Baseline for Figure 33-14 v320

33.2.7 Power supply output

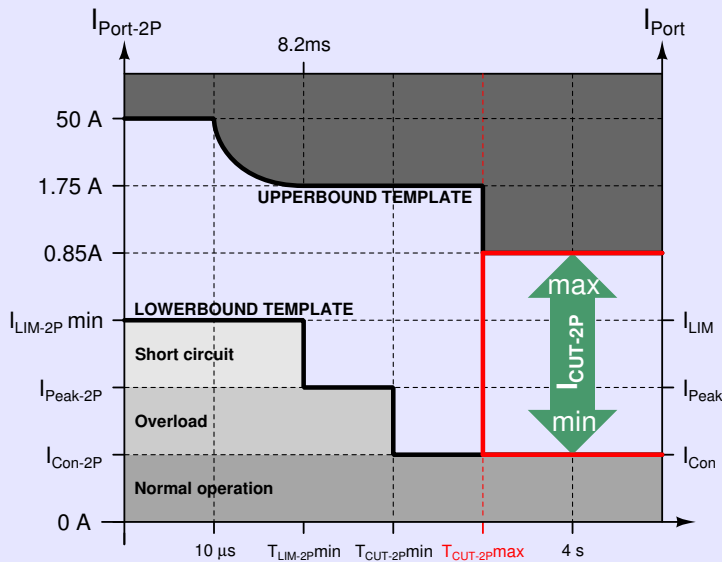
I_{CUT-2P} is an optional limit a PSE can implement to perform power management. The minimum is defined by the lowerbound template at $t > T_{CUT-2P\ max}$ and the maximum is defined by the upperbound template also for $t > T_{CUT-2P\ max}$. This is the current D1.4 definition for I_{CUT-2P} :

For every Type, the definition of I_{CUT-2P} must match with Figure 33-14 and needs to have a range as follows:

$I_{CUT-2P\ min}$ The minimum current the PSE must be able to support, this matches with the lowerbound template and the value is I_{Con-2P} . I_{Con-2P} already handles unbalance in its various definitions.

$I_{CUT-2P\ max}$ The maximum current a PSE may sustain, matching with the upperbound template.

Replace Table 33-11, Item 7 by:

Item	Parameter	Symbol	Unit	Min	Max	PSE Type	Add. Info
7	Overload current per pairset, detection range	I_{CUT-2P}	A	P_{Class} / V_{PSE}	I_{LIM-2P}	1, 2	Optional limit; see 33.2.7.6, Table 33-7.
				I_{Con-2P}	0.85	3	
					I_{LPS}	4

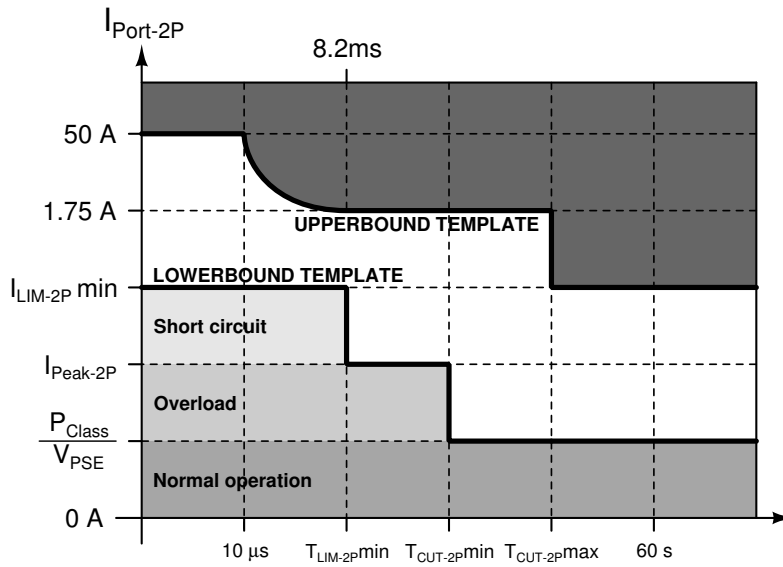
For dual-signature PDs we will need to define a P_{Peak_PD-2P} in the PD section.

Replace Figures 33-14a:

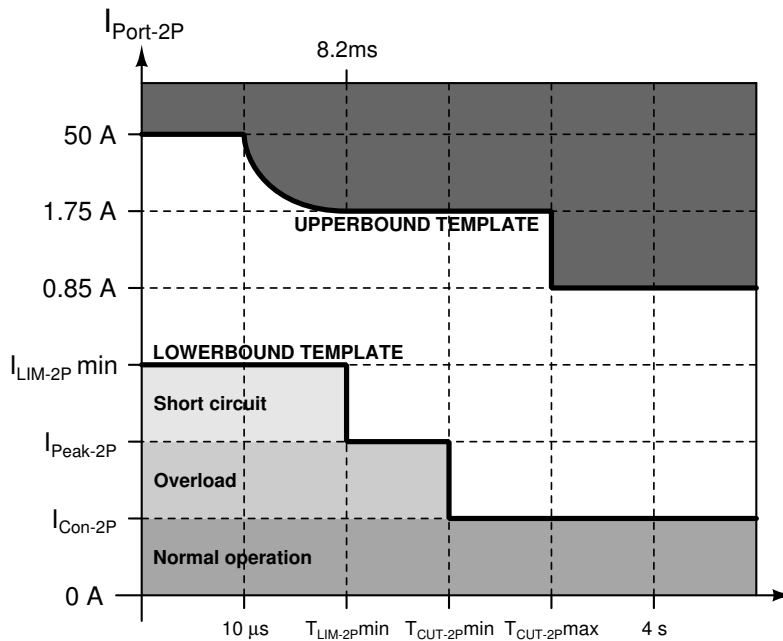
Apart from fixing minor inconsistencies, the only change is that I_{LIM} and I_{Peak} have been added to the I_{Port} axis in Figures 33-14b and 33-14c.
